**AGREEMENT ROUTING SHEET
(FOR INTERNAL USE ONLY)**

Initiating Department:	TA	Contact Name/Phone:	Gabrielle Whelan x6818
Agreement Title:	Newtown Tolling Agreement		
Term of Agreement: From	March 18, 2025	To	December 31, 2027
Date Approved By Council:	March 18, 2025	Item or Resolution #:	14
Vendor Name:	Green Valley Corporation (Swenson)		
Vendor Email:	case@swenson.com	Vendor Phone:	-
Vendor Contact:	Case Swenson		
Business License #:	-	Expiration Date:	-
Insurance (IHH) #:	-	Expiration Date:	-

**STAFF TECHNICAL REVIEW
PLANNING DIVISION
December 23, 2024**

PROJECT PLANNER: Sean Mullin

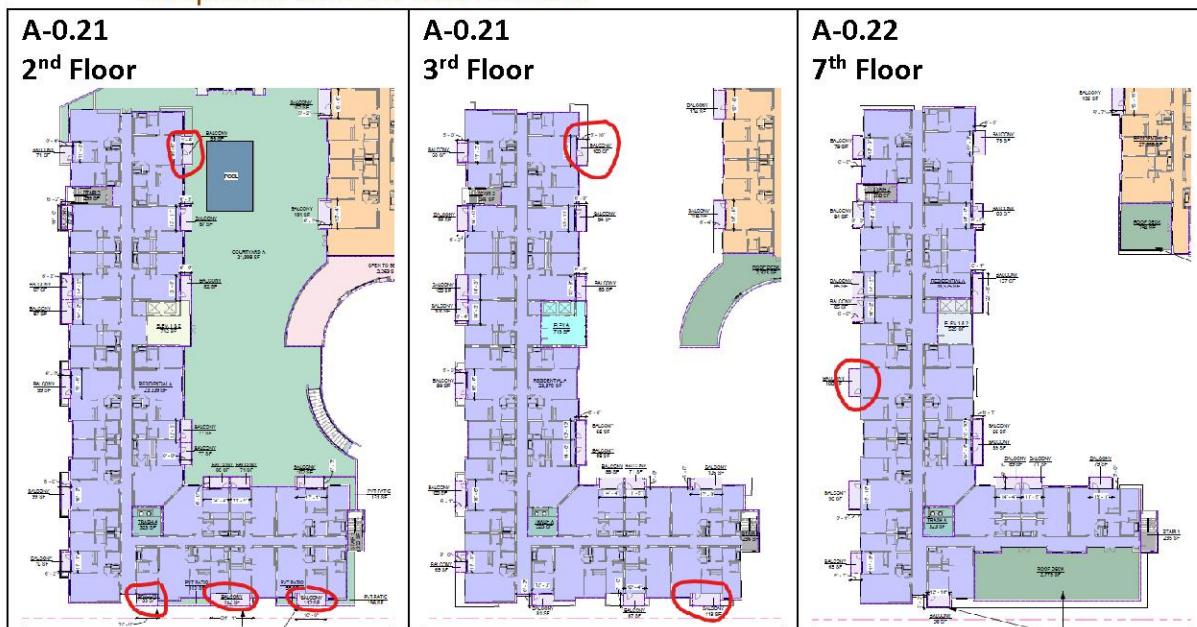
Staff Response: The circled balconies on the plans referenced below either do not meet the minimum six-foot dimension or do not provide dimensions to show compliance with the ODS A.11.1.b.

11/26/24 Response: Please refer to the Area plans sheets A-0.20 to A-0.22 and A-0.65 for balcony sizes.

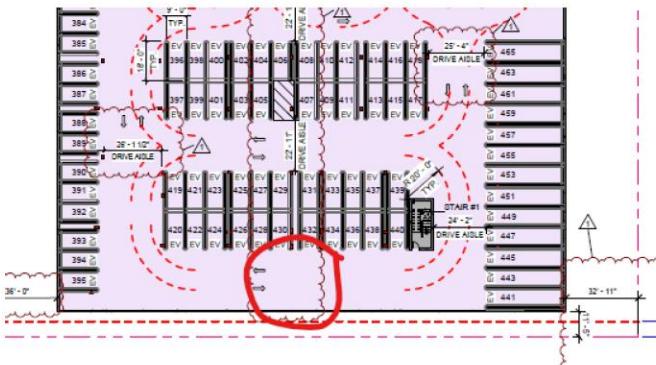
a) Aisle widths shall be a minimum of 22 feet for two-way aisles. Several two-way aisles do not meet the 22-foot width requirement. [29.10.155 (d)(2)]

Staff Response: Add dimension to the circled aisle on Sheet A-2.00 shown below.

11/26/24 Response: All the drive aisles were revised to meet the min 22' width and clouded on basement and 1st floor plans, sheets A-2.00 and A-2.01.
